# COM-SKH Rev. A1.3 BLOCK DIAGRAM

Title <b>TITLE BLOCK</b>		
Size B	Document Number <b>COM-SKHB6</b>	Rev. <b>A0.2</b>
Date: Thursday, June 02, 2022		Sheet: 1 of 41

# COM-SKHB6 Revision History

Title <b>DP to VGA</b>		
Size B	Document Number <b>COM-SKHB6</b>	Rev: <b>A0.2</b>
Date: Thursday, June 02, 2022		Sheet: 27 of 41

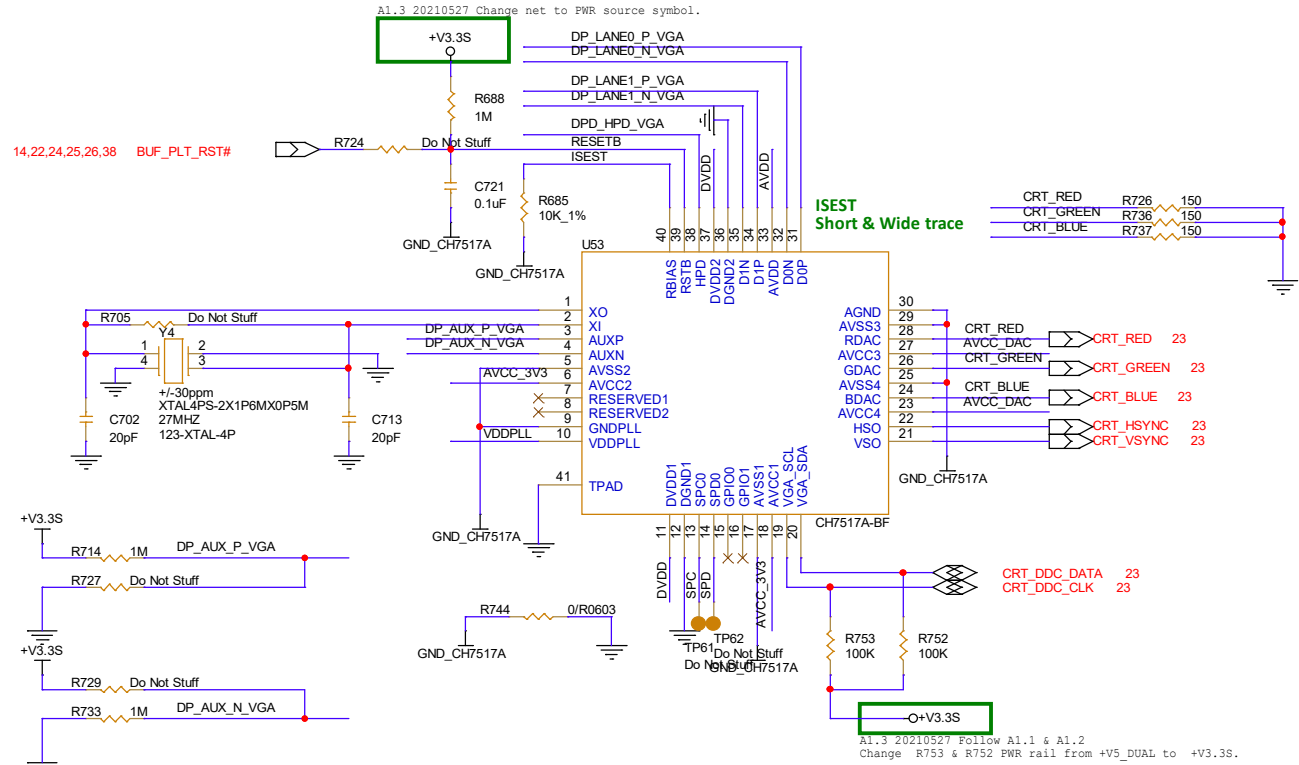
A1.3 20210527 Follow A1.1 & A1.2  
Change R753 & R752 PWR rail from +V5\_DUAL to +V3.3S.

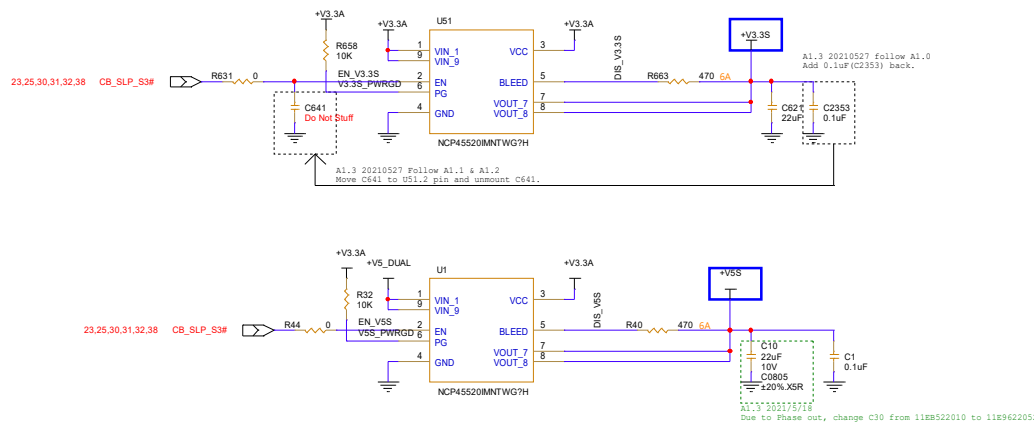
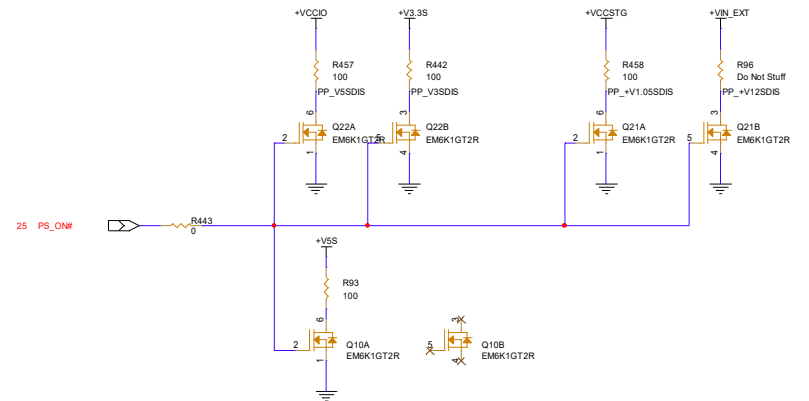
A1.3 Due to alternative L6 (size bigger)  
Remove R117 (+VCCST CPU PWRGD) for saving PCB space.
